Appendix 2: Petition - Request to improve road safety of Hamilton Road junction with Crescent Road

RESIDENTS' COMMENTS, AND IDEAS FOR IMPROVED SAFETY AT CROSSROADS
1.	I'd like the police to fine electric bike/scooter riders as I believe they are still illegal.

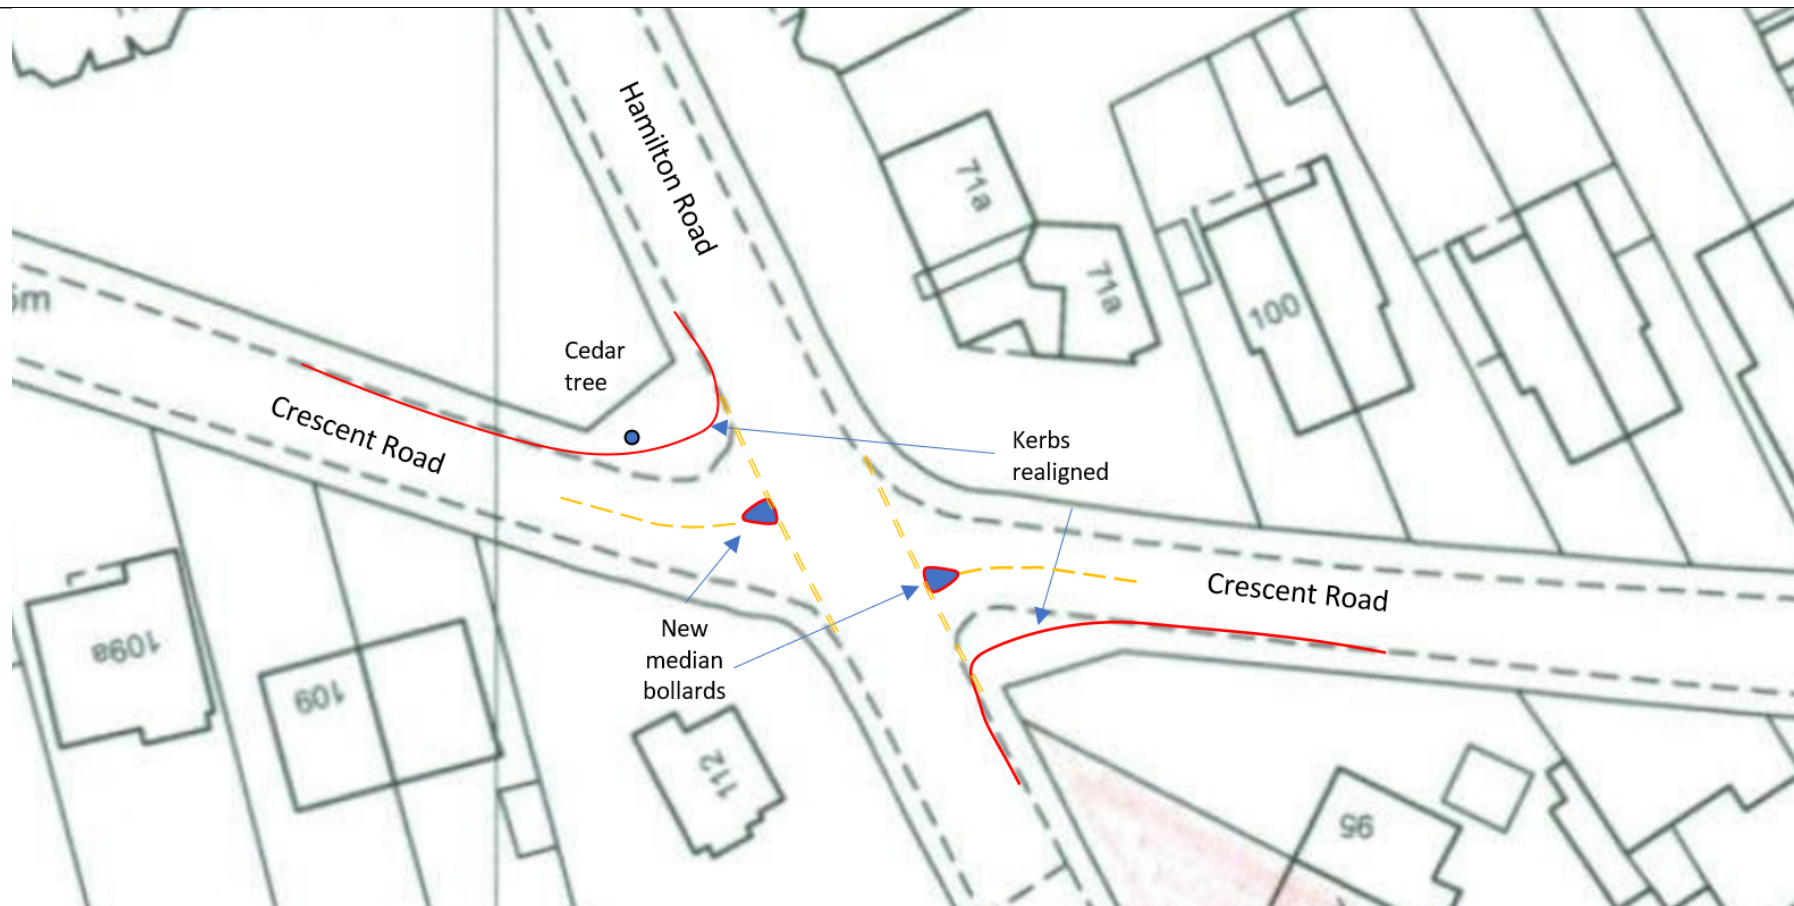
20	I somehow doubt that having a Stop sign instead of a Give Way sign would have made any difference to their extremely dangerous behaviour. I suggest that some sort of vibrator alert be placed across the Crescent Road road-surface about 20 or so yards prior to the junction, or rumble strips.
21	I suggest: make a minor reconfiguration of the carriageway such as to force approaching cars to change their line and to block the direct straight-through alignment by inserting bollards . It would also entail realigning the kerbs and sacrificing a little bit of the pavements , and of course there is a cost to be incurred. The chief difficulty would be in choosing an alignment that avoids the cedar tree while still meeting vehicle clearances and design guidelines. (see: plan 1.) I did think about a mini roundabout , but space is the issue.

21	Whatever solution we go for, I think the key to it is to prevent vehicles on Crescent Road from having an unhindered straight-through line, by forcing them to steer round some sort of obstacles. Design guidelines will determine the dimensions and hence the maximum vehicle size that can make each turning manoeuvre.
23	Chicanes would also be good way to slow the traffic
24	How about planting a big tree in the middle and blocking the junction to motorized traffic - just have filters for cyclists - so Hamilton and Crescent Roads would both have no through traffic. (see plan 2.) (Plan not supplied)
